METROPOLITAN AREA PLANNING
DEPARTMENT

Re: Final Plat S/D 87-121 - KILLARNEY PLAZA 2ND ADDITION

STAFF REPORT
(Final Plat; Revised Preliminary Plat 12/17/87;
Original Preliminary Approved 5/21/87)

CASE NUMBER: S/D 87-121 - KILLARNEY PLAZA 2ND ADDITION

KILLARNEY PLAZA SECOND ADDITION

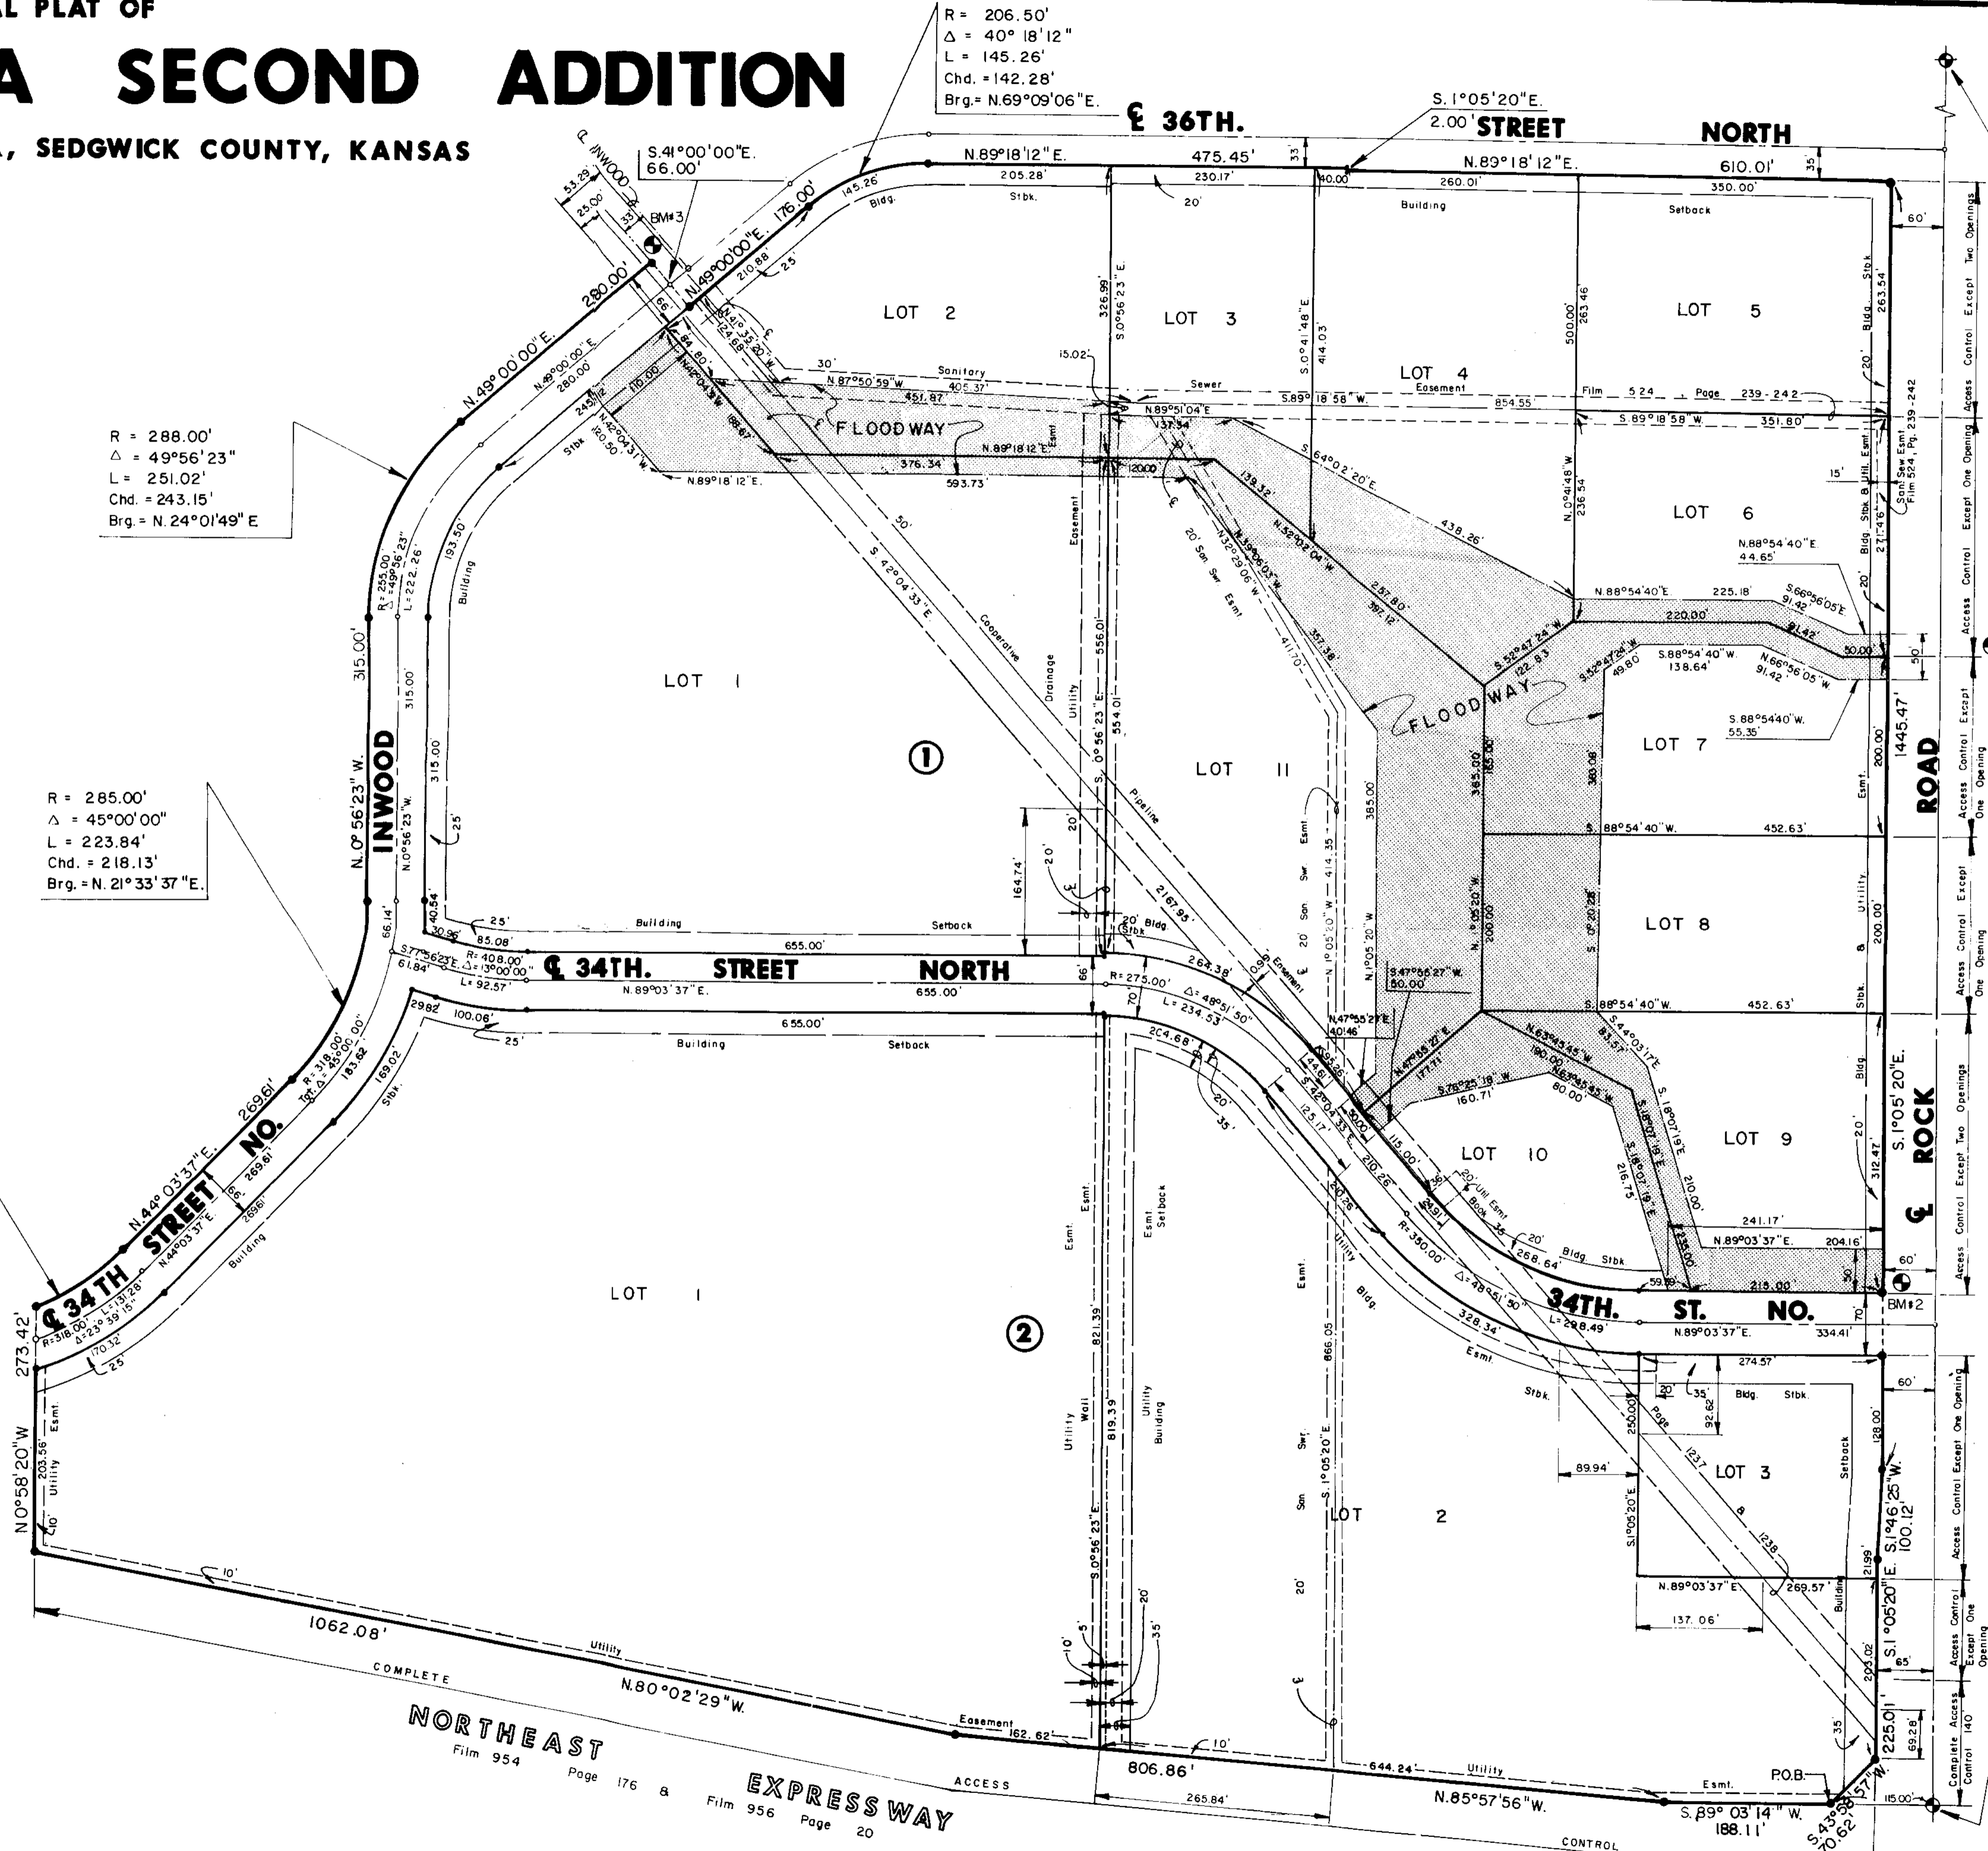
- AA. The representative from the City Engineer's office should be prepared to comment on the status of the applicant's drainage plan. Specifically, are the minimum building pad elevations correct, are the boundaries of the floodway adequate and what drainage guarantees besides storm sewers are required?

- J. Any relocation, lowering or encasement of the pipeline, made necessary by this development, will not be at the expense of the City.
- K. On the final plat tracing, the platlor's text shall be amended to reference the platting of "complete access control" across the south line of the plat.

- M. On the final plat tracing, the centerlines of the perimeter streets shall be labeled.
- N. On the final plat tracing, the platting of the minimum building pad elevations shall be referenced in the plat's text. Section 5-402(P)

- O. As this property is establishing minimum building pad elevations, the face of the plat shall reference the location and elevation of permanent on-site and off-site benchmarks. Section 5-402(N)

- P. The final plat tracing shall correct the M.A.P.C. signature block to reference MARVIN S. KROUT as the M.A.P.C. Secretary.
- Q. On the final plat tracing, the City Council signature block shall be amended to reference Dale E. Rea, Deputy City Clerk.

- R. On the final plat tracing, Elton Parson's middle initial shall be deleted from the MAPC signature block.
- S. On the final plat tracing, the wording in the plat's text, regarding the restriction of uses in the floodway, shall be amended to reference "the City of Wichita" rather than "a governing body exercising jurisdiction".

- T. On the final plat tracing, the plat's text shall be amended to state that changes in the floodway shall not occur "without" the permission of the City Engineer.

- U. On the final plat tracing, the surveyor's text shall be amended to reference that a surveyor has prepared this plat, not a civil engineer. Section 5-402(R)(3)
